TIMELY OPE TIPS FOR THE MONTH - 1980

TIMELY OPE TIPS FOR THE MONTH

ISSUE # 71

TIP # 1 - K1, K2 Cab Installation Tip:

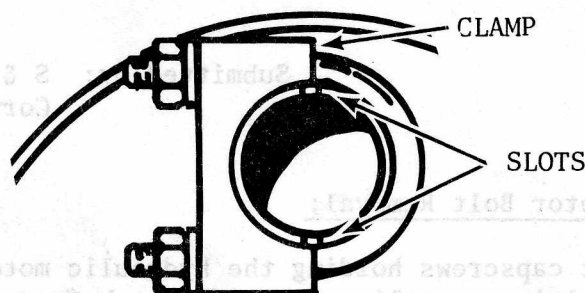
On some units it may appear that the rear mounting panel fits too tightly between the rear fenders.

The fender mounting holes are slotted to allow a small amount of extra clearance. Loosen the fender mounting bolts and push the fenders outward to obtain this clearance.

Tighten the fender mounting bolts after the rear mounting panel is installed.

TIP # 1 - K1, K2 Cab Installation Tip:

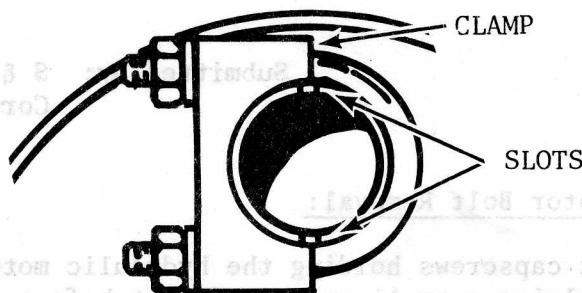
On some units it may appear that the rear mounting panel fits too tightly between the rear fenders.

The fender mounting holes are slotted to allow a small amount of extra clearance. Loosen the fender mounting bolts and push the fenders outward to obtain this clearance.

Tighten the fender mounting bolts after the rear mounting panel is installed.

TIP # 1 - 646B Backhoe Hose Routing Change:

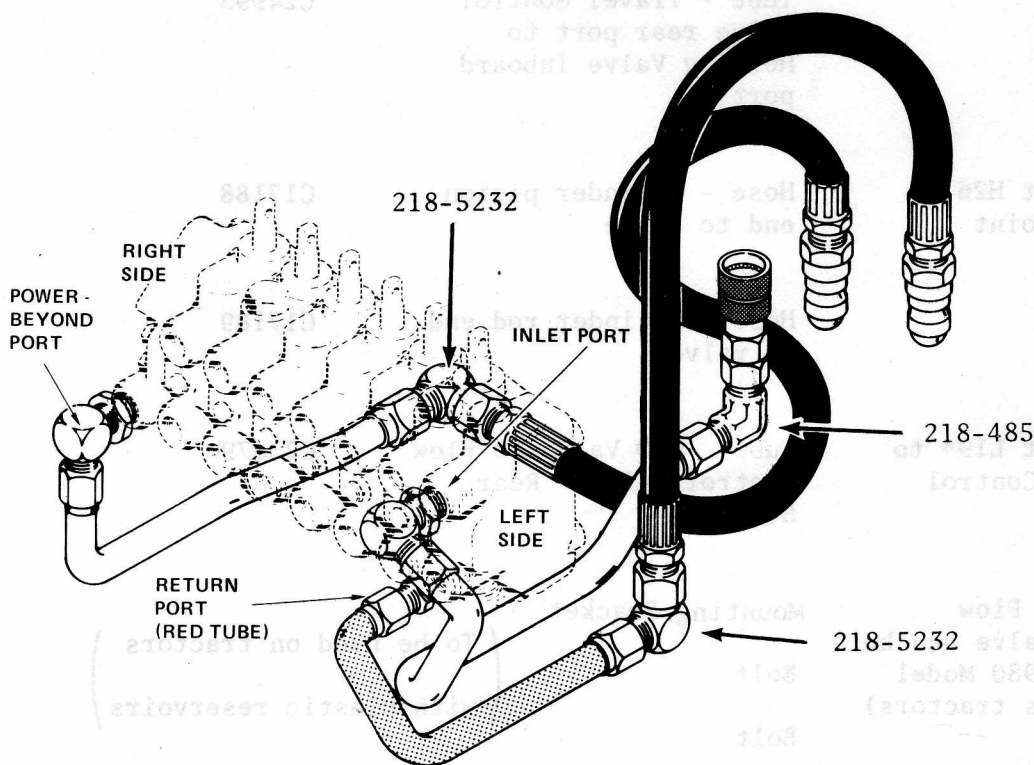
The hose routing between the tractor and backhoe has been changed to eliminate interference with the seat. 646B's after PIN 9791000 have this change.

Elbows have been added as illustrated to the tubes at the backhoe valve bank.

TIP # 2 - Model 210 Jackshaft Kit, Part Number C25594 (CONTINUED):

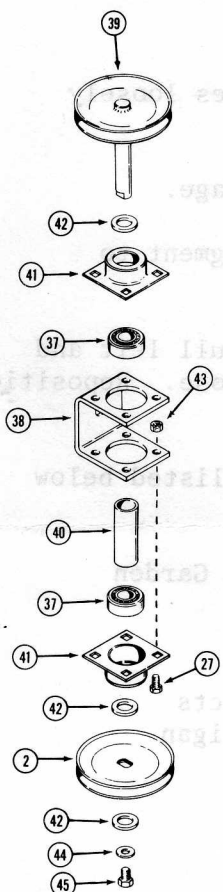
It is suggested that this kit be installed when replacement of jackshaft and bearings is required on these tractors.

The kit includes heavy duty bearings, a spacer to lock the inside bearing races, shaft, mounting brackets, hardware and instructions.

TIP # 1 - Mod 80 Chain Housing Support Bar:

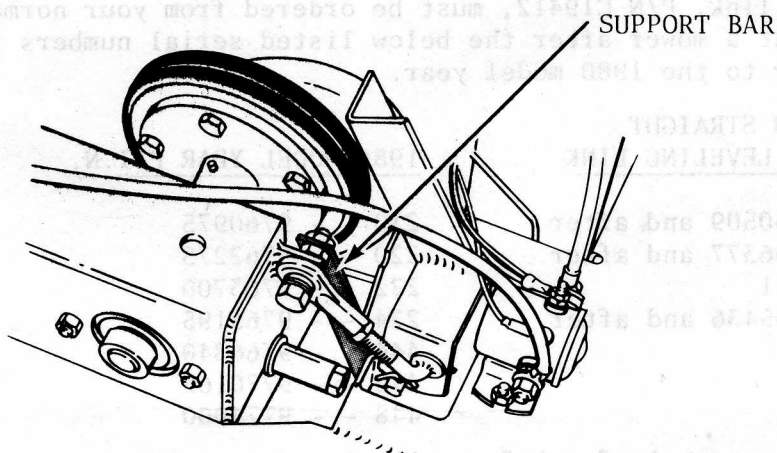
To prevent the possibility of bending the threaded stud on the front of the chain housing as a result of shock loads and vibrations during shipment this support bar has been installed on this clutch link mounting bolt to hold the chain housing off the pivot plate. This support bar must be removed and discarded during set-up and predelivery in order to make the riding mower operational.

The support bar was first used with Mod 80 Product Identification Number 9775698.

TIP #1 - K-41 Mower Drive Belts:

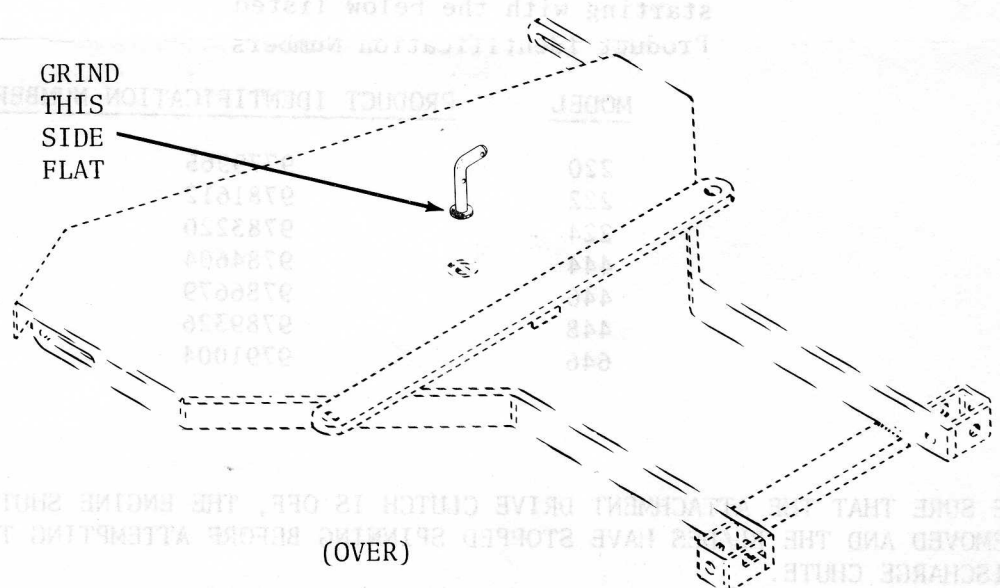
Reports indicate that contact can still exist between the mower drive belt and the lift link.

The washer welded to the bottom of the lift link must be ground flat on one side (illustrated below) to provide adequate clearance.

GRIND
THIS
SIDE
FLAT

Make certain that the lift link is installed through the tractor lift lever from the right hand side as illustrated in Figure 8 of Operator's Manual #9-50622.

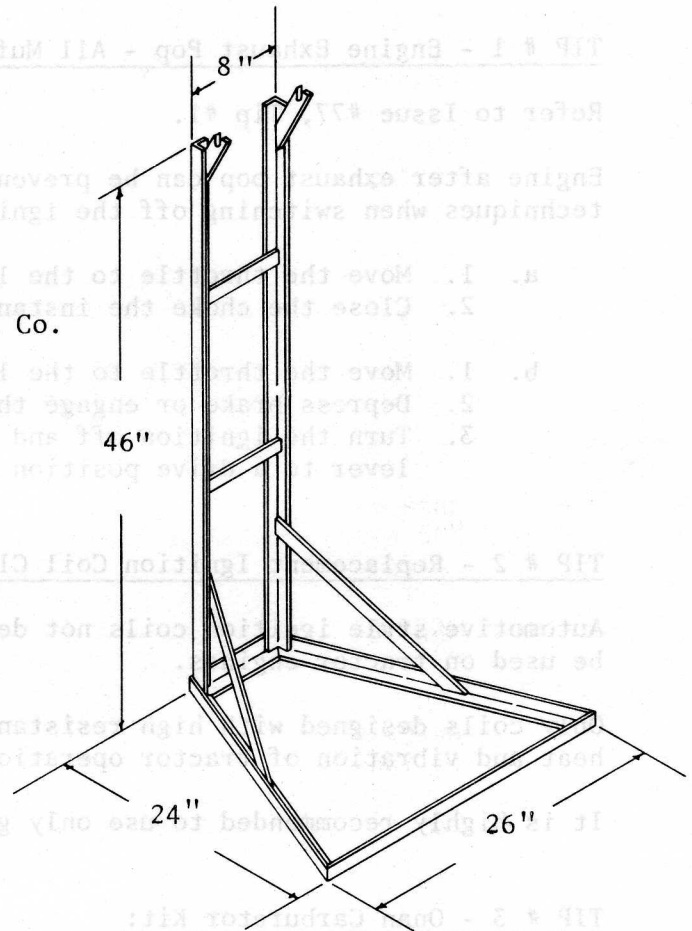
The front support bracket should be about 46" (1170 mm) high when used with 200 series tractors with slots at the top for the tractor anchor pins.

The base should extend about 24" (610 mm) under the tractor to provide adequate stability. Use 1-1/8" (28 mm) angle iron.

TIP # 2 - Street Pads for D-100 Backhoe Stabilizers:

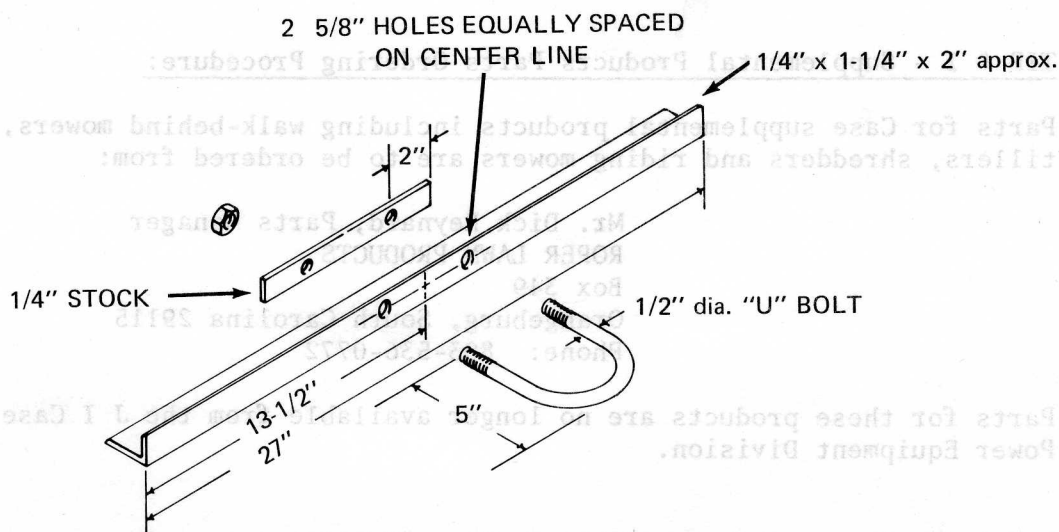
Steel pads can be added to the D-100 backhoe stabilizer pads at customer expense if desired.

Use part number R31222, one per stabilizer. Install according to the diagram.

TIP # 1 - Tractor Travel Control Valve - Self-Return to Neutral:

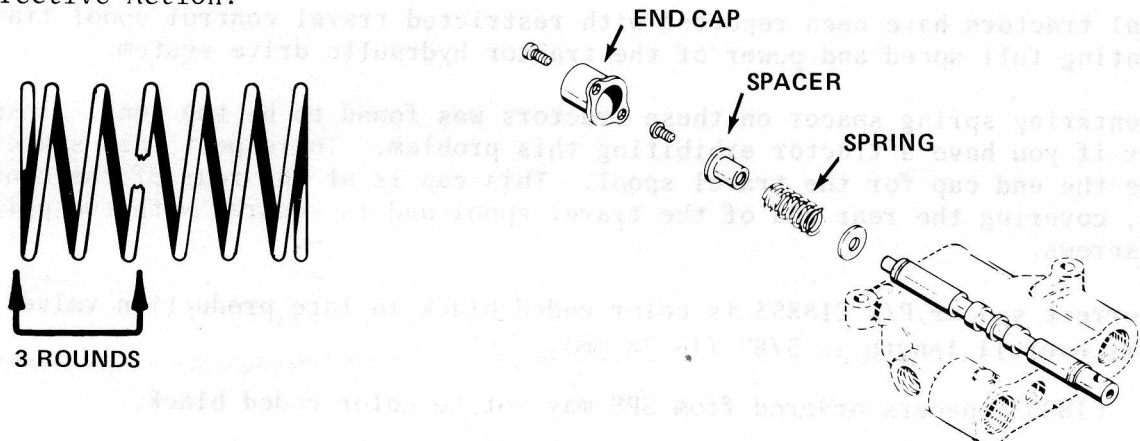
Effective with the P.I.N.'s listed below, a centering spring was added to the travel control spool. The purpose of the centering spring is to prevent the spool from moving past the neutral position when applying the brake from either the forward or reverse position.

1. Remove the end cap for the travel spool. This cap is at the rear of the control valve, covering the rear end of the travel spool and is secured with two phillips head screws.
2. Cut 3 rounds from one end of the spring with a good pair of wire cutting pliers.

3. Remove the 3 round portion of the of the spring. Make certain that the clipped end of the shortened spring seats properly against the end of the spacer and does not interfere with the inside of the end cap.
4. Install the cap and its screws and internal tooth lockwashers.

TIP # 2 - Tractor Travel Control Valve - Restricted Spool Travel:

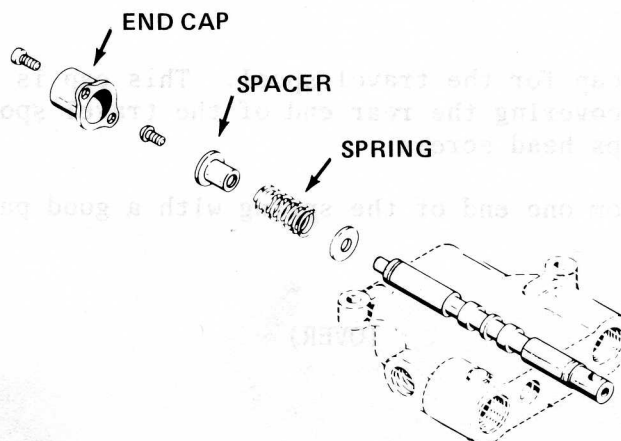
Several tractors have been reported with restricted travel control spool travel preventing full speed and power of the tractor hydraulic drive system.

The centering spring spacer on these tractors was found to be too long. Inspect the spacer if you have a tractor exhibiting this problem. To inspect this spacer, remove the end cap for the travel spool. This cap is at the rear of the control valve, covering the rear end of the travel spool and is secured with two phillips head screws.

The correct spacer P/N C18853 is color coded black in late production valves and its overall length is 5/8" (15.88 mm).

Remove the control valve and replace the spacer if the wrong spacer is found.

TIP # 2 - Snow Caster Lift Arm Interference 446 - 448 Tractors: (CONTINUED)

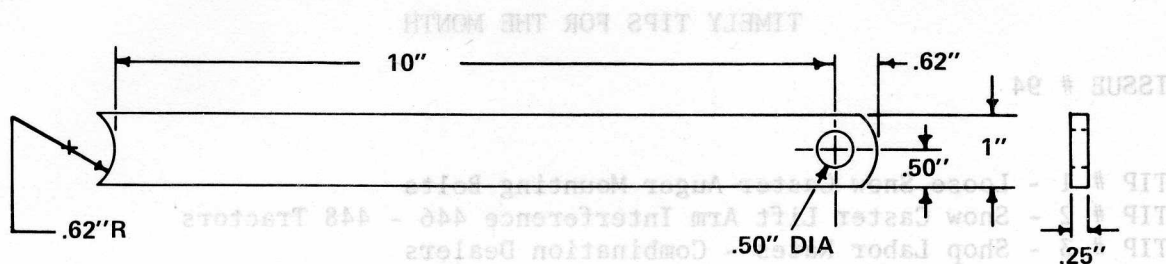
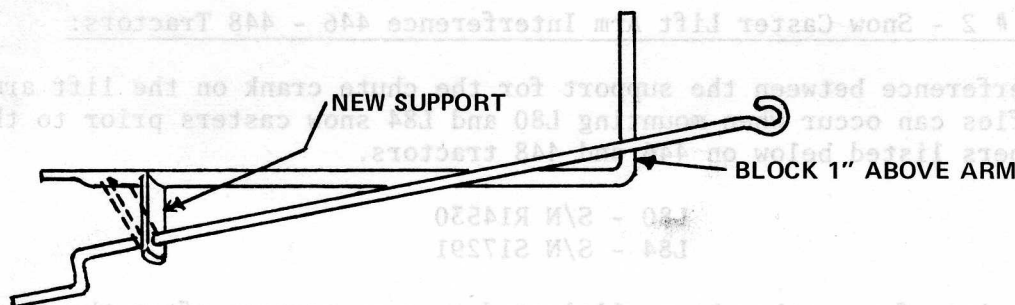
Interference between the support for the chute crank on the lift arm and engine baffles can occur when mounting L80 and L84 snow casters prior to the serial numbers listed below on 446 and 448 tractors.

This interference has been eliminated on snow casters after the above listed serial numbers by shortening the support and moving it forward on the lift arm.

If this interference occurs, use the following procedure to insure proper alignment of the chute crank support.

4. Support the hooked end of the crank approximately 1 inch above the lift arm. See illustration below.
5. Hold the top of the new chute crank support close to and in alignment with the support on the lift arm.
6. Allow the bottom of the new chute crank support to swing forward until it contacts the lift arm.
7. Weld the new chute crank support to the lift arm.
8. Cut the old support off. Grind and paint as required. Save the old support for use on other snow casters you may have in stock.
9. Normal warranty will apply.
